NUMBER: 08-017-13

Flash: Vehicle Theft Alarm Intermittently Sounds

2011 - 2012 (WK) Grand Cherokee (International only)

Fig. 1 Module and Tape Placement Location

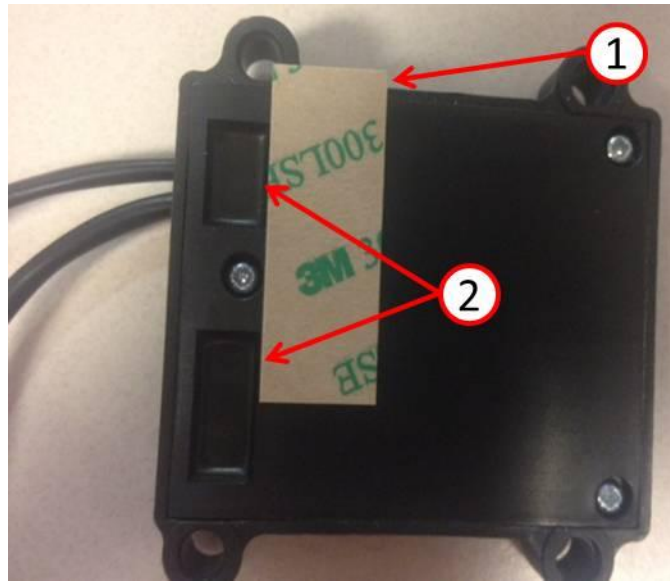
1. Reprogram the Intrusion module. Help using the wiTECH Diagnostic Application for flashing the Intrusion module is made available through the wiTECH Diagnostic Application. For instructions select the "HELP" tab on upper portion of the wiTECH window, then "HELP CONTENTS." This will open the Welcome to wiTECH Help screen where help topics can be selected.
2. Clear any DTC's that may have been set in other modules due to reprogramming. The wiTECH application will automatically present all DTCs after the flash and allow the tech to clear them.
3. Remove the overhead console to gain access to the Intrusion module. Follow procedures in TechCONNECT, 23 - Body / Interior / CONSOLE, Overhead, Front/Removal.
4. Lower the module and check if the back side of the module is clean were the tape is going to be placed, clean if necessary.
5. Apply the tape as shown in (Fig. 1).

1 - Leave a tab at this location.

2 - Line up the tape along these indents.
